RE: Kenai Airport Fuel Service, Spill #90230026801  
UST Facility ID #2187  
Submittal of Remedial Action Schedule

Attention: Monica T. English, Environmental Specialist

RE: Kenai Airport Fuel Service—Spill #90-23-00-268-01  
UST Facility ID #2187  
Submittal of Remedial Action Work Plan

Remedial Action Work Plan  
Kenai Airport Fuel Service  
Kenai, Alaska

Figure 1-2. KAFS Site Map.

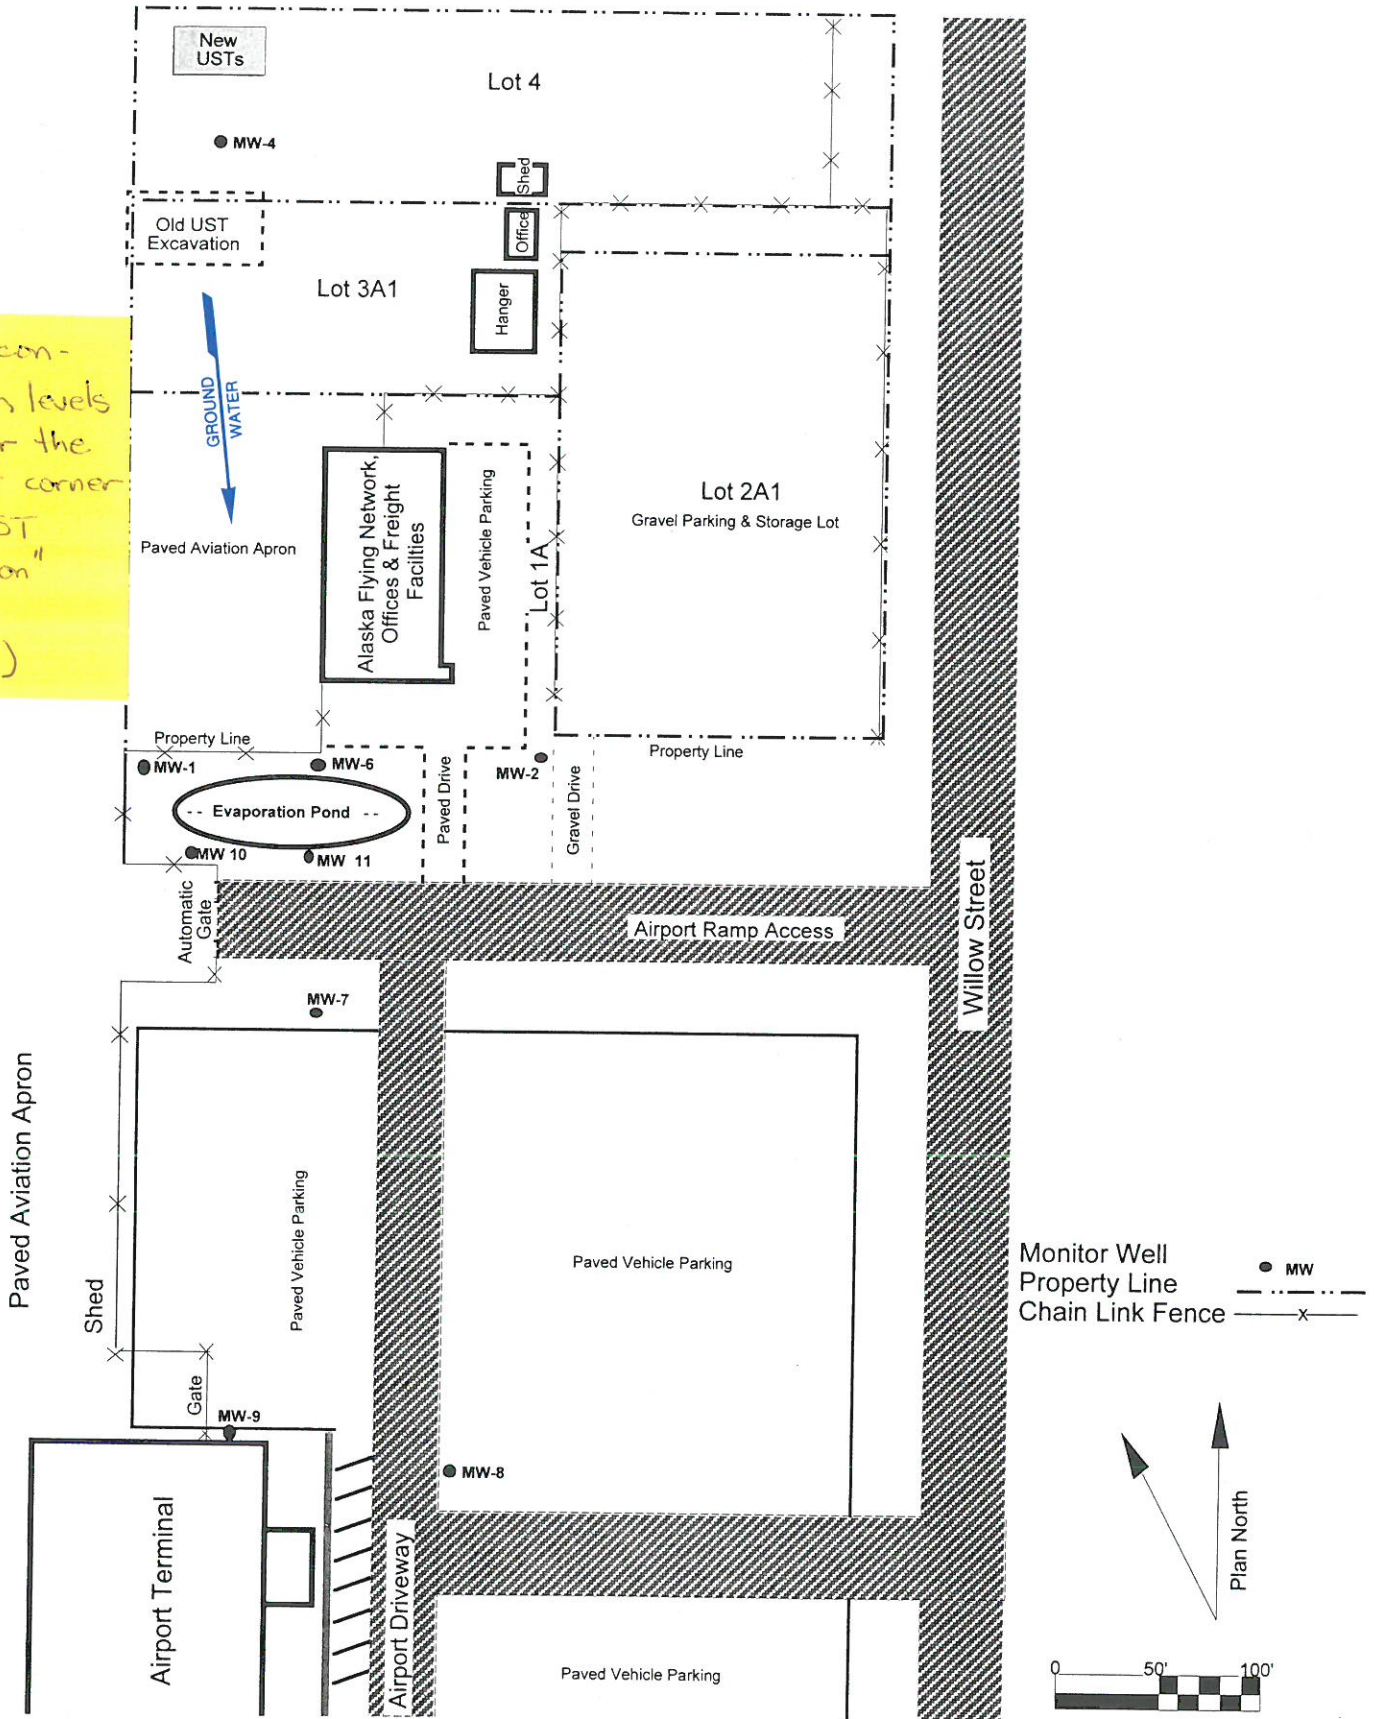
"Highest con-  
tamination levels  
were near the  
northwest corner  
of the UST  
excavation"  
page 1-4  
(1.2.3)

Figure 2-1. May 2002 GRO Plume Map.

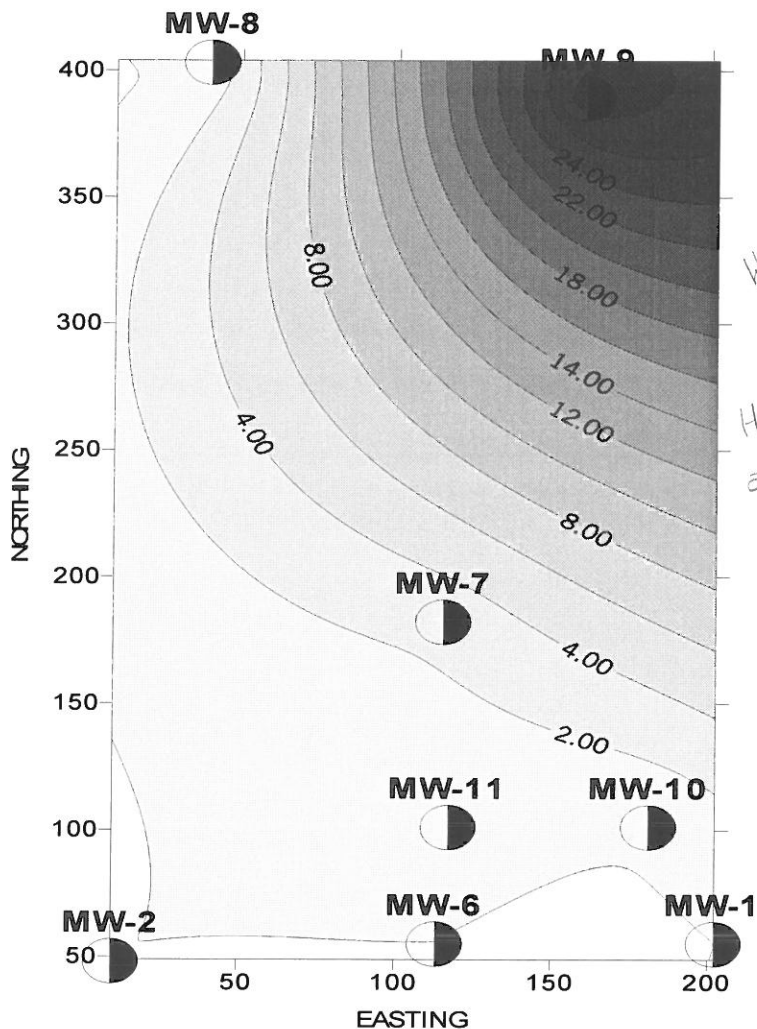
*Surfer*  
 - Modeling of Oct sample results?  
 Which program generated this plume map?  
 Have you looked @ a benzene plume map?
